SUBJECT: Forwards response to RAI during 930726 meeting re restart of PVNGS, Unit 2, in support of Unit 2 SGTR rept & SG tube evaluation submitted via 930718 & 25 ltrs. Proprietary info also encl. Proprietary info withheld. *Report*

**Subject: Palo Verde Nuclear Generating Station (PVNGS)
Units 1, 2 and 3
Docket Nos. STN 50-528/529/530
Steam Generator Tube Rupture Analysis
File: 93-056-026**

The following information is provided in response to questions asked by the NRC staff at the July 26, 1993, meeting discussing the restart of PVNGS Unit 2.

FIGURE 2

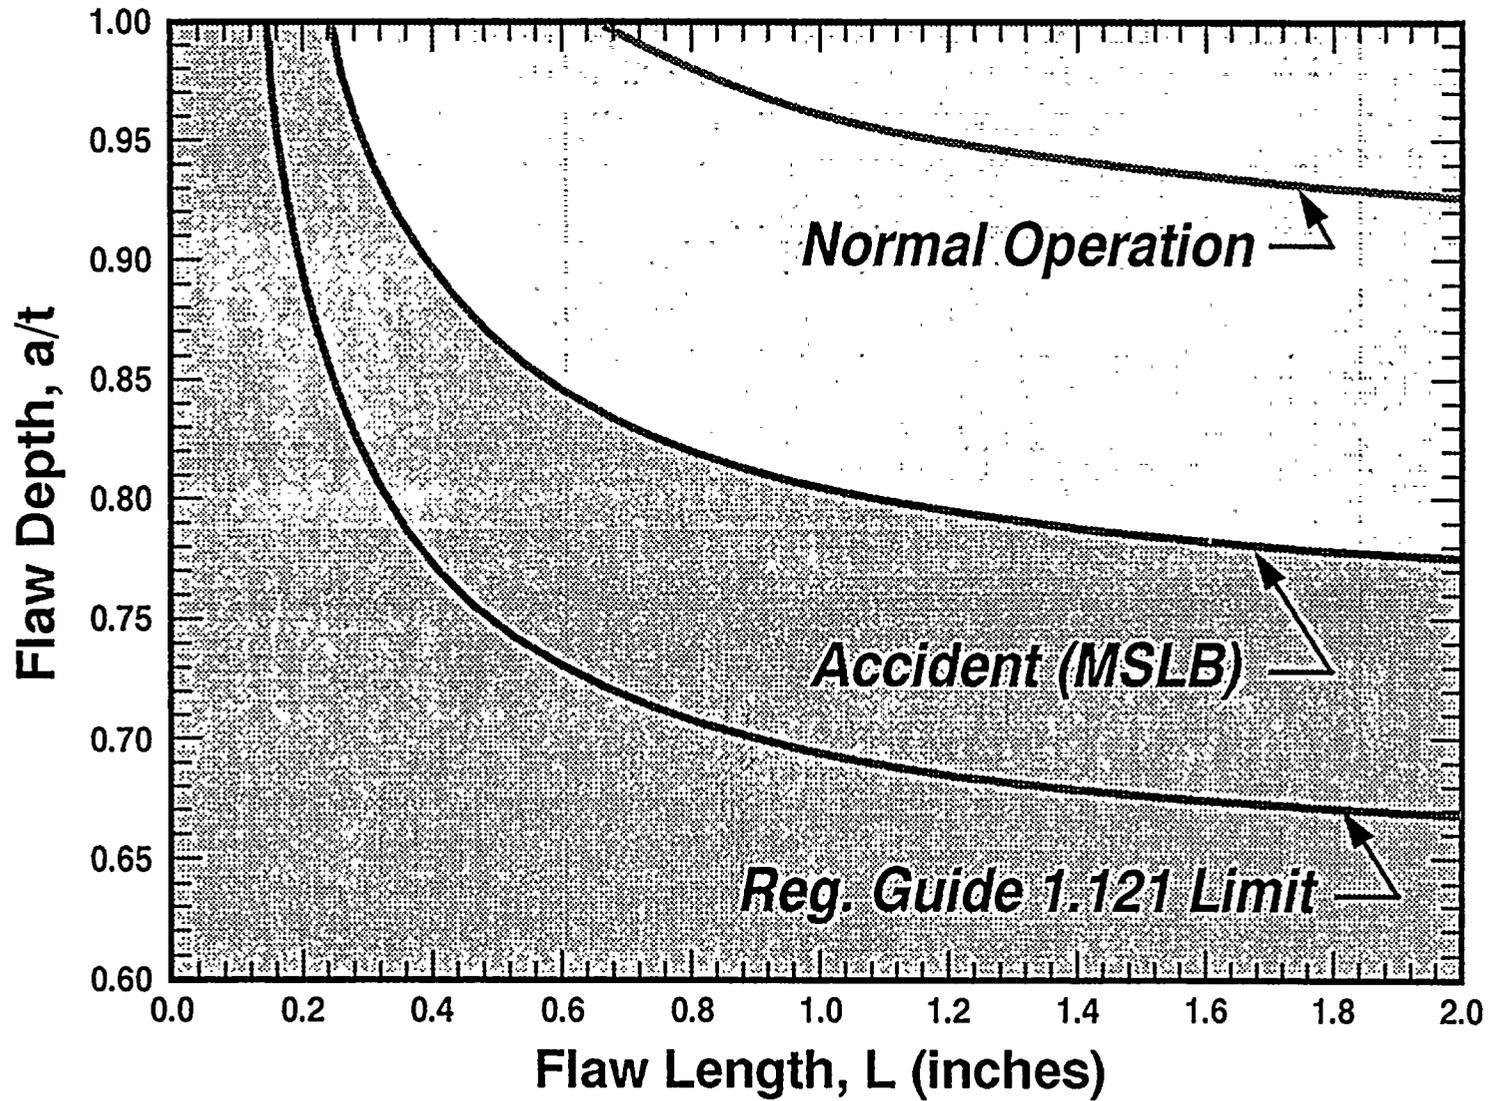
Regulatory Guide 1.121 Evaluation Using a More Conservative Burst Correlation

At the request of the NRC, APS has performed a comparative Regulatory Guide 1.121 evaluation using a more conservative burst correlation than originally used by APS in the attachment to letter 102-02569-WFC/JRP dated July 18, 1993 (Reference 1) and discussed in a meeting with NRC on July 26, 1993. Use of this more conservative correlation developed by Battelle reduces the allowable operating cycle length from 6 months to 4.5 months. However, as described below, it is APS's position that our Regulatory Guide evaluation already contains sufficient conservatism and the additional conservatism resulting from the use of the Battelle correlation is not warranted.

Using the Battelle correlation, the maximum allowable crack depth as a function of length can be determined and compared with the Framatome correlation results as illustrated in Figure 2. This comparison indicates that the Battelle correlation yields a more conservative (i.e. shallower allowable crack depth) result for cracks longer than approximately 0.5 inches. It is noted that the Battelle correlation results in a maximum allowable depth of 60% for all cracks longer than 1.6 inches.

FIGURE 3

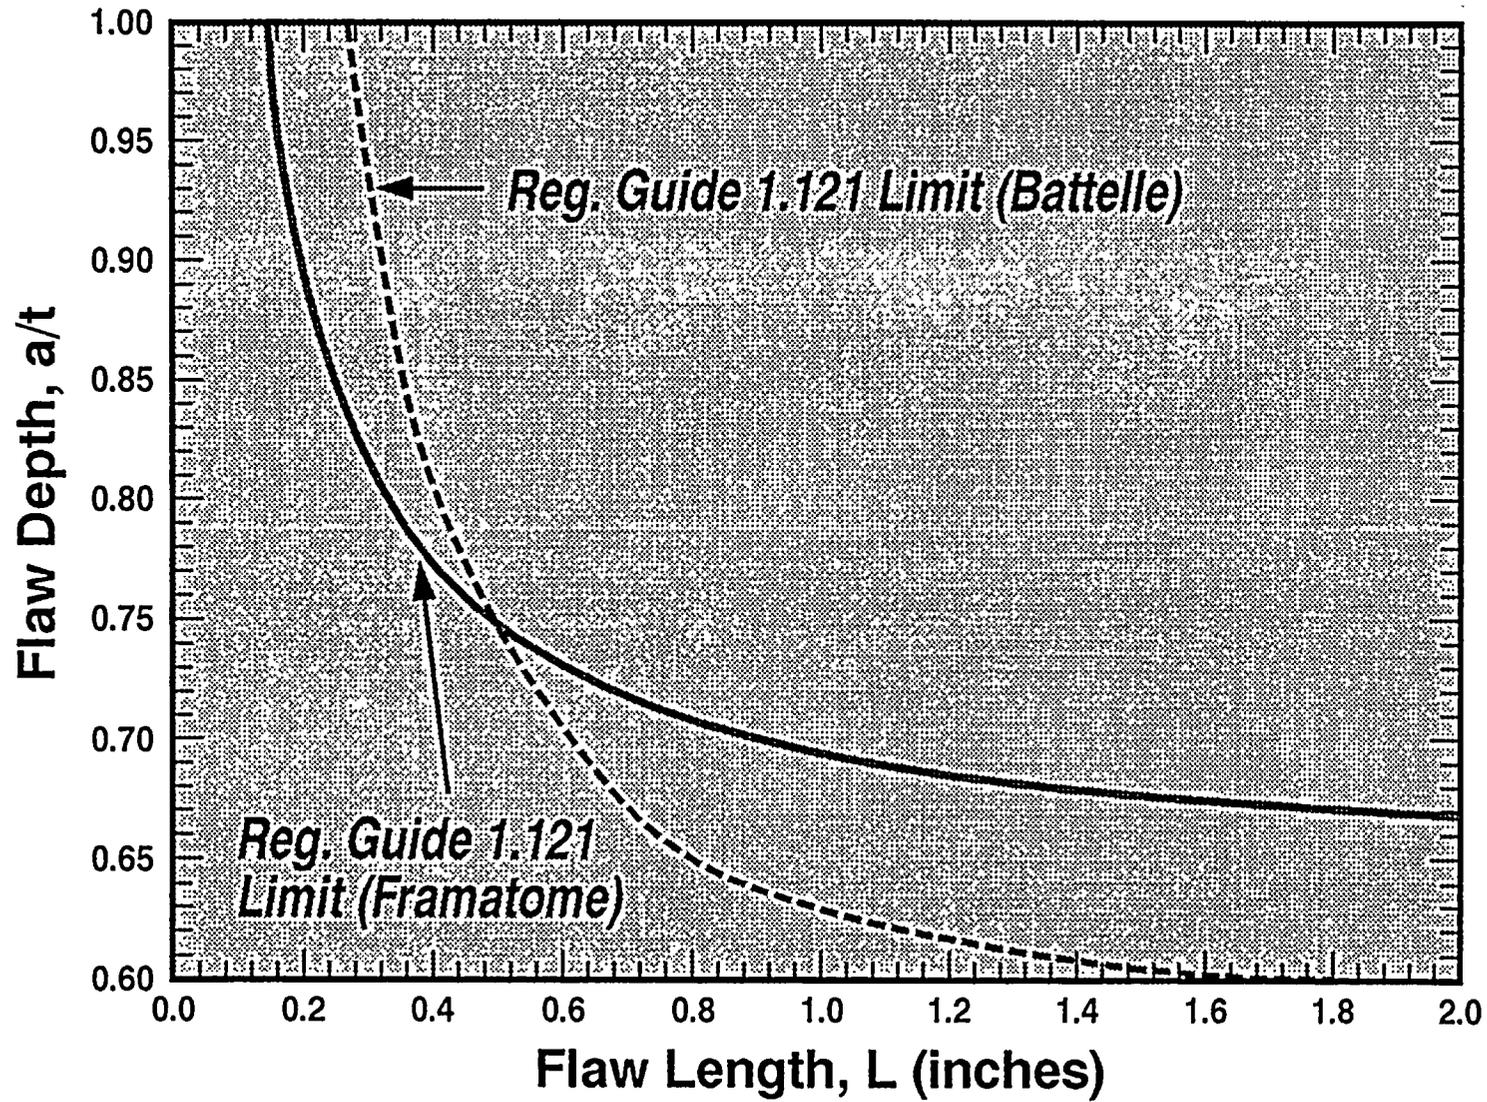
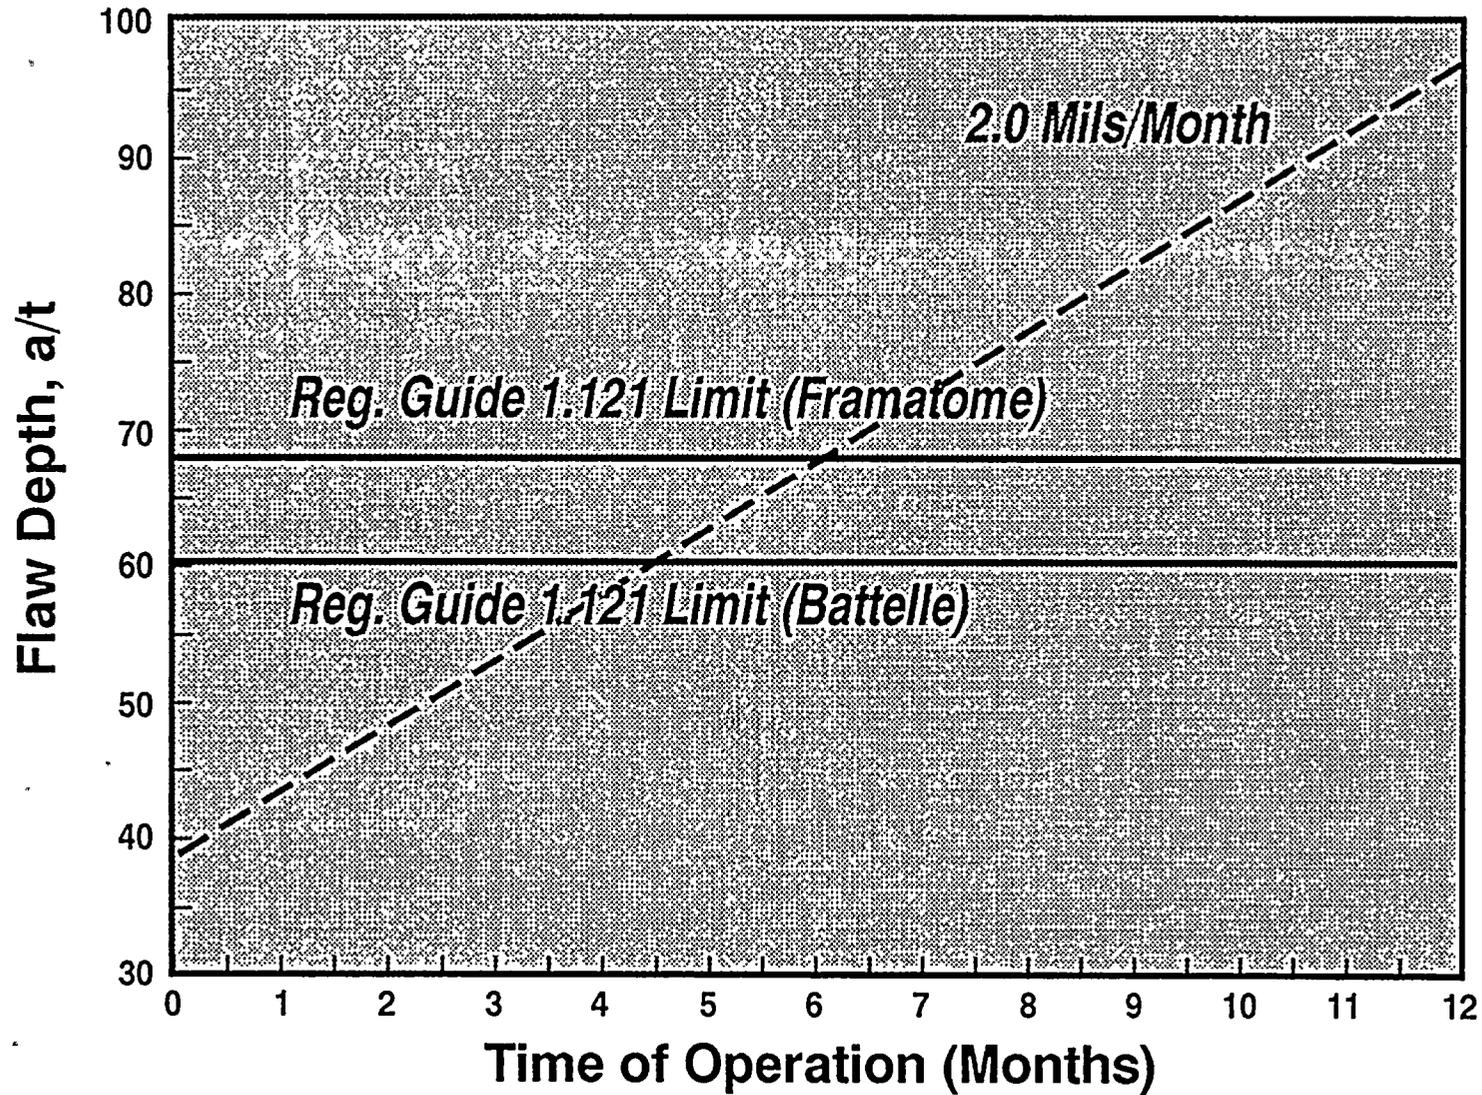
As described in Reference 1, the determination of a maximum allowable crack depth requires consideration of crack length. Assuming 1.4 inches to be an expected limiting crack length for the next operating cycle, the Battelle correlation yields a maximum allowable crack depth of 61%, compared to 68% using the Framatome correlation. This translates into an operating cycle length of approximately 4.5 months is illustrated in Figure 3.

FIGURE 4

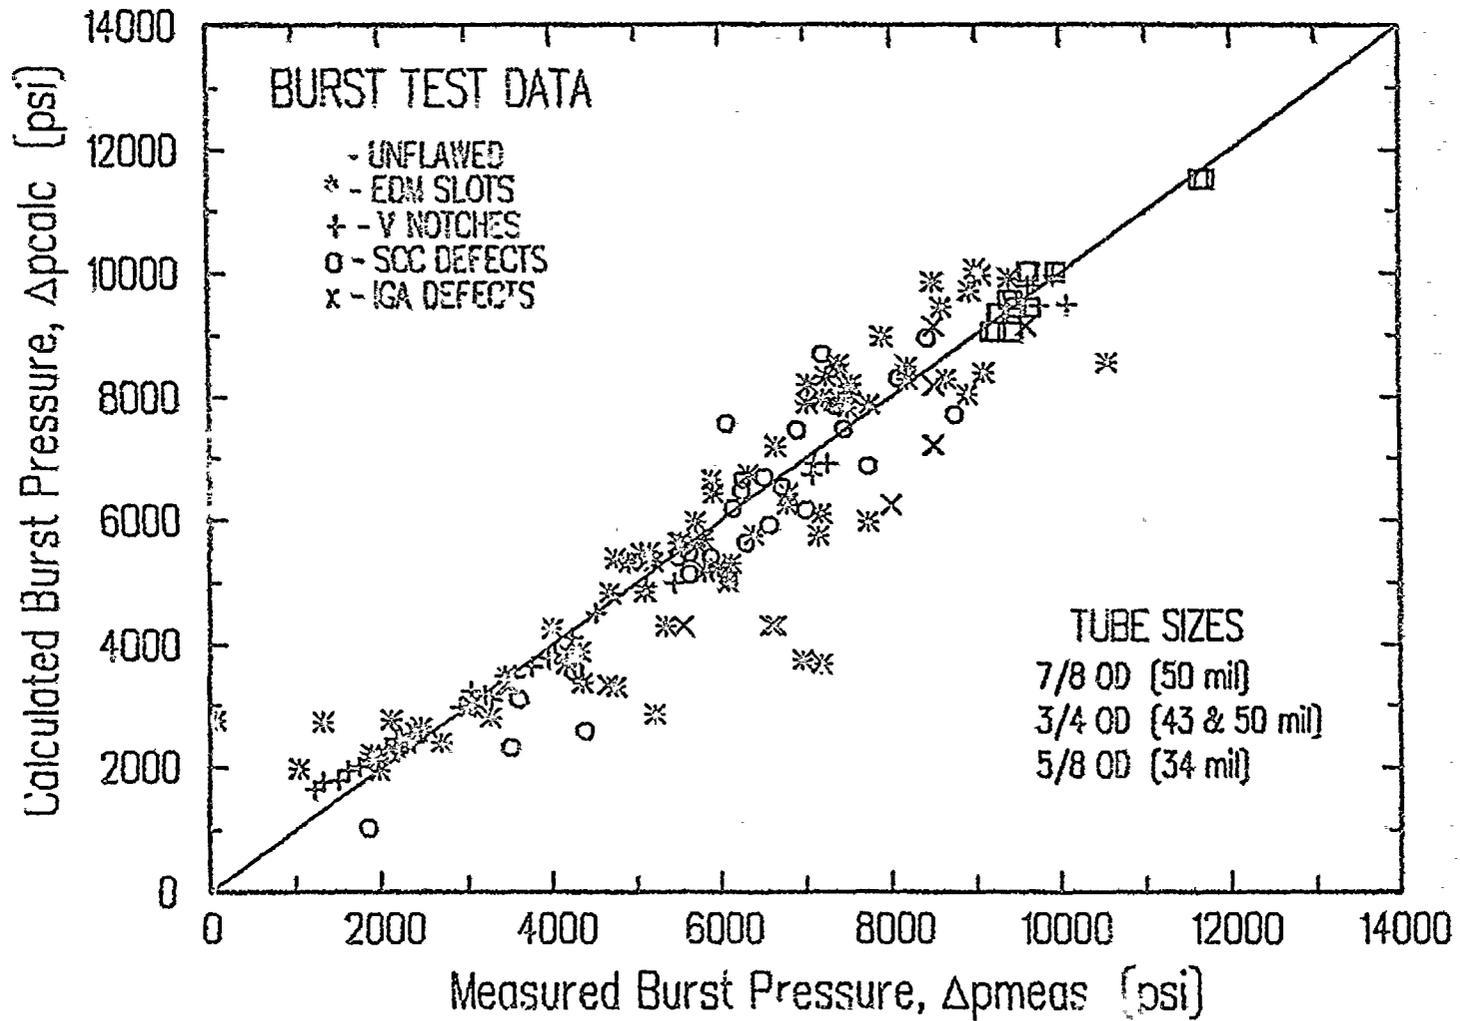
As was previously noted by APS in Section X.B of Reference 1, other correlations available in the industry literature would provide a more conservative prediction of burst pressure. The Framatome correlation was chosen to provide the best comparison with available burst test data. Figures 4 and 5 provide a comparison with burst test data using each of the two correlations. It is APS's judgement that the Framatome correlation provides the superior correlation. Figure 6 provides a comparison with the actual burst test results from the PVNGS Unit 2 pulled tubes using both correlations. Again the Framatome correlation provides the superior, yet sufficiently conservative comparison.

FIGURE 7
**Normalized Burst Pressure vs.
 Flaw Length for $0.5 < a/t < 0.6$**

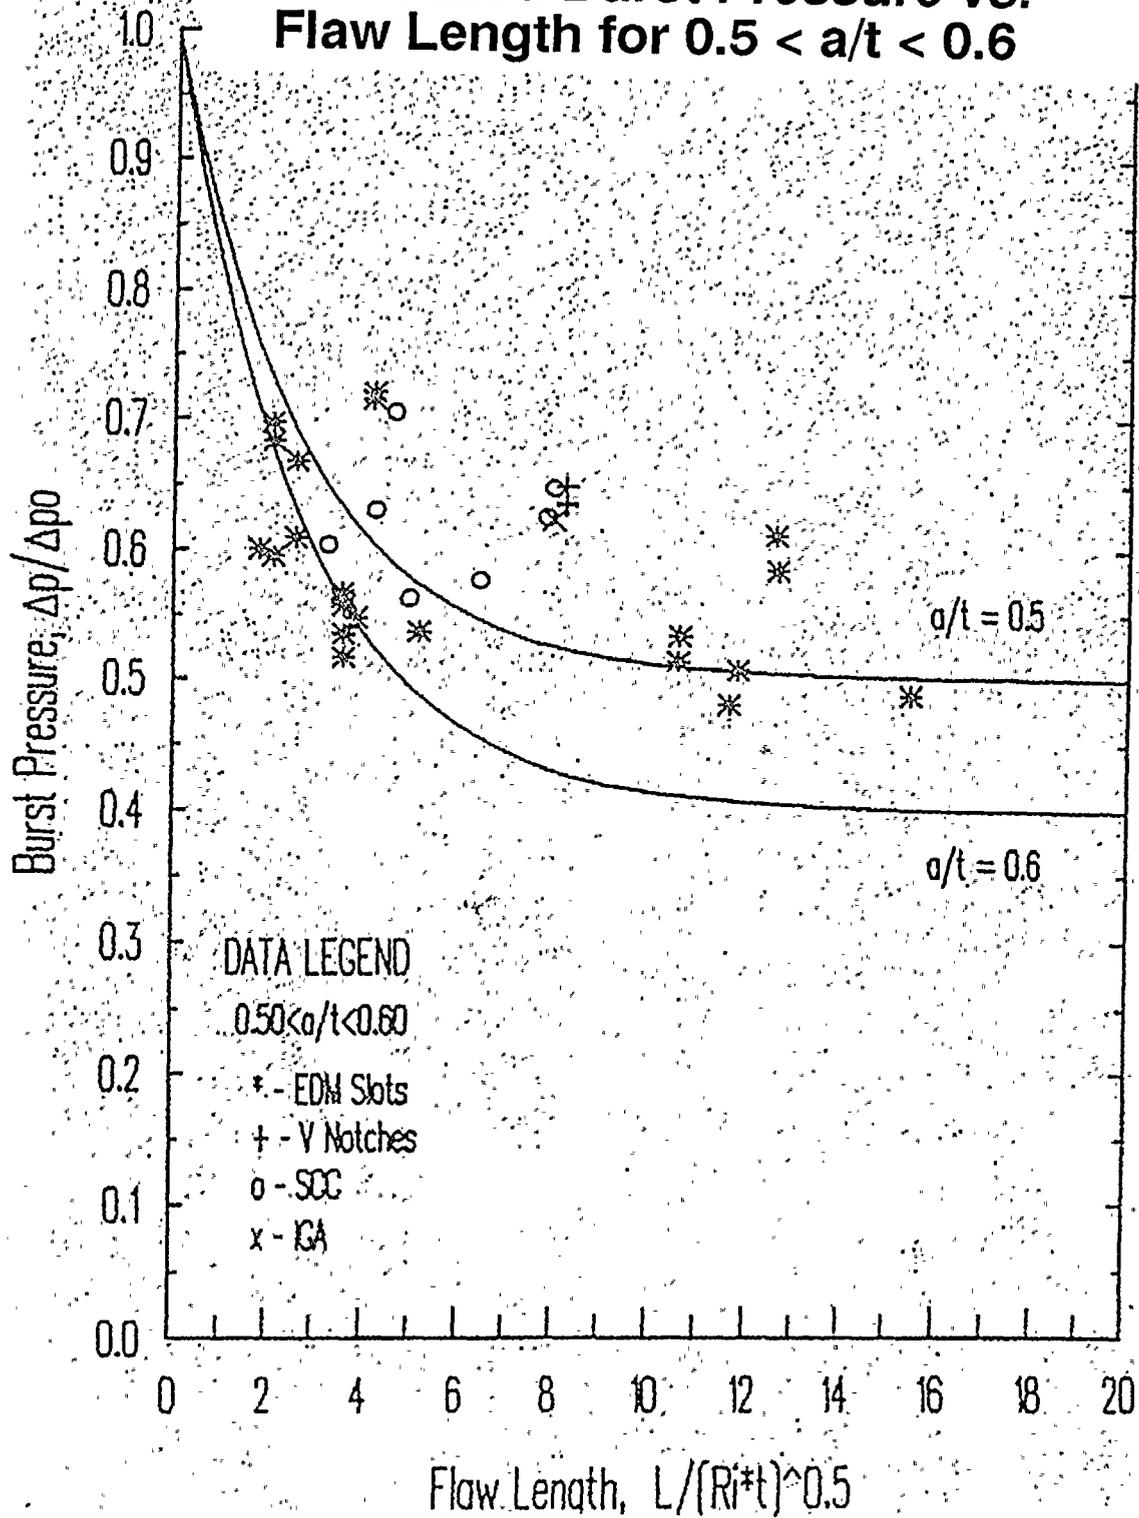
APS and its consultants had initially considered using the Battelle correlation, but found the correlation to be overly conservative for long cracks greater than approximately 0.75 inches. Data analysis of burst test results was performed to identify overly conservative trends. An example of the results of this data analysis is shown in Figure 7. This figure compares actual burst pressure versus predicted burst pressure, using the Battelle correlation, as a function of normalized crack length for crack depths between 50% and 60% throughwall. This comparison indicates that almost all cracks greater than normalized flaw length of 8 (which is equal to approximately 0.75 inches long actual length) burst well above the predicted pressure, while the actual burst pressure for shorter cracks was in much better agreement with prediction. It is for this reason that APS chose not to use the Battelle correlation since it resulted in overly conservative predictions for longer cracks.

FIGURE 1
TECHNIQUE QUALIFICATION
ODSCC Prime/QTR Diff Mix-Bobbin
Fraction Detected & POD @90% C/L

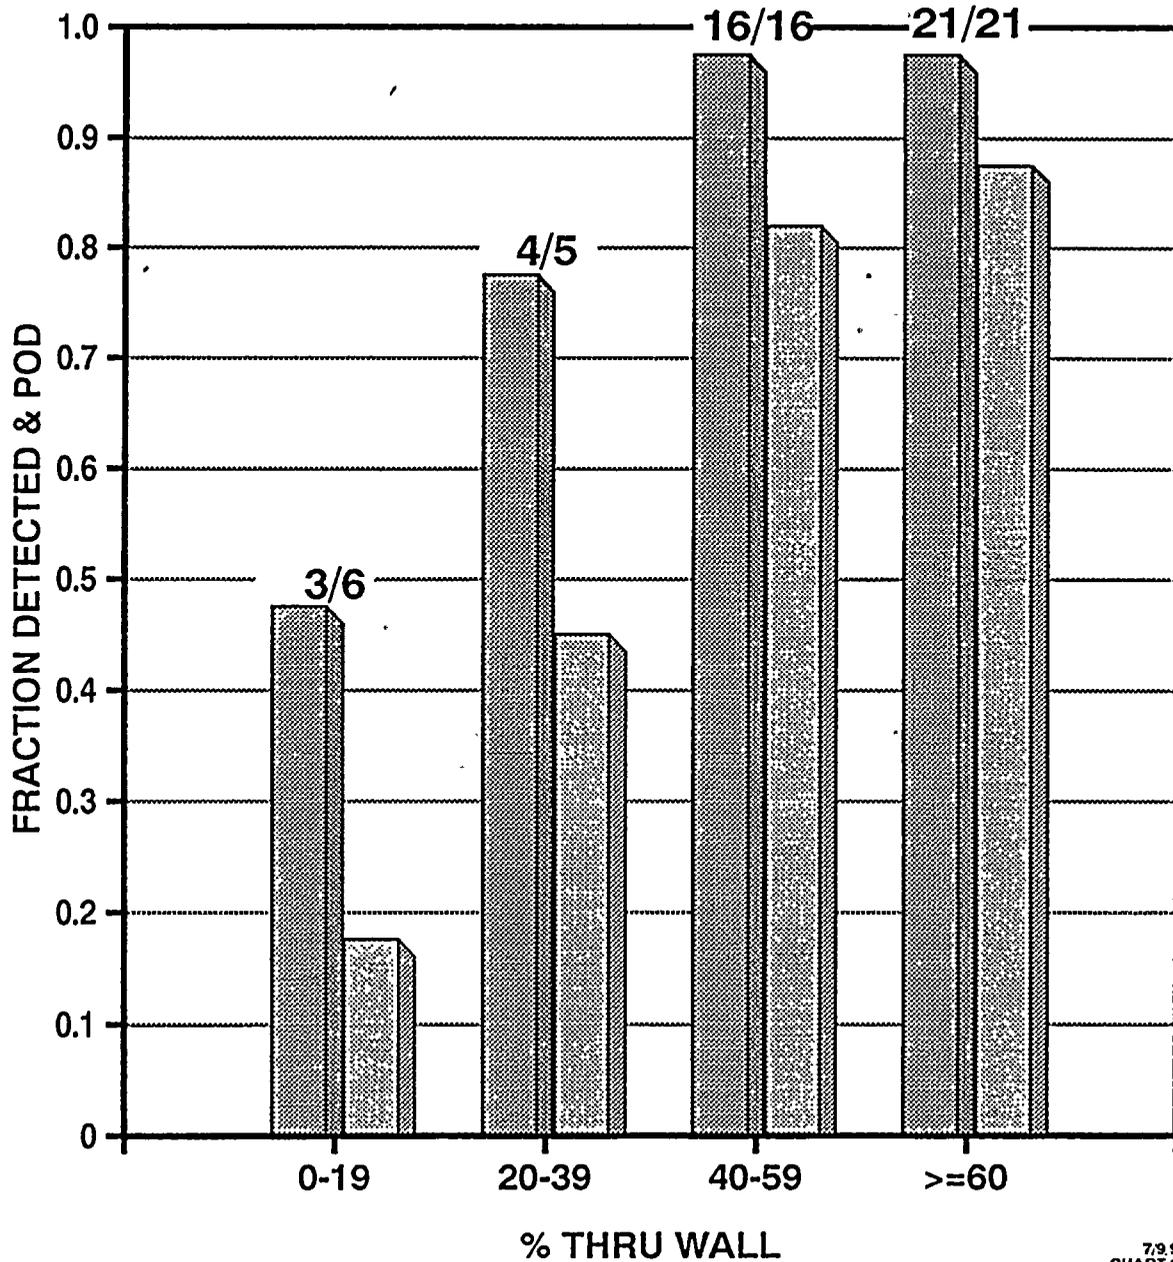
The NRC requested additional clarification regarding eddy current detectability threshold, which was used by APS in a Regulatory Guide 1.121 evaluation described in Section X of the Attachment to letter 102-02569-WFC/JRP dated July 18, 1993 (Reference 1) and discussed in a meeting with NRC on July 26, 1993. Specifically NRC requested an explanation of the development of attached Figure 1, which was presented at the above referenced meeting.

Figure 1 was presented as supporting evidence that general industry experience indicates reliable detection with bobbin coil of IGSCC cracks greater than 50% in depth. This graph was prepared by EPRI during eddy current technique (for detecting ODSCC) qualification. The graph was constructed using data from actual pulled tube samples and laboratory-induced stress corrosion cracking specimens. The pre-pull field eddy current data or the laboratory eddy current data was then reviewed by NDE Center eddy current analysts to determine if the technique being qualified produced detectable signals. The particular technique involves a differential mix of the prime channel frequency and 1/4 prime channel frequency. APS uses a 550/100 mix which is equivalent to a prime/one quarter prime mix. Therefore, although the data was used to qualify a technique, it does indicate whether a particular flaw produced a detectable signal. Accordingly, the data is representative of detectability capability. Note that this graph indicates a detectability threshold of 40%, while APS conservatively used a 50% bobbin coil threshold in its Regulatory Guide 1.121 evaluation.

In addition to the EPRI data, APS considered the results from pulled tube data at McGuire, ANO-1, and Beaver Valley. These results indicated a reliable detectability threshold of approximately 50%. Accordingly, 50% was considered to be representative of industry experience against which PVNGS Unit 2 pulled tube results were compared with. As described in Section VII.B.2 of Reference 1, the results from the Unit 2 pulled tubes are considered to be consistent with this industry experience.
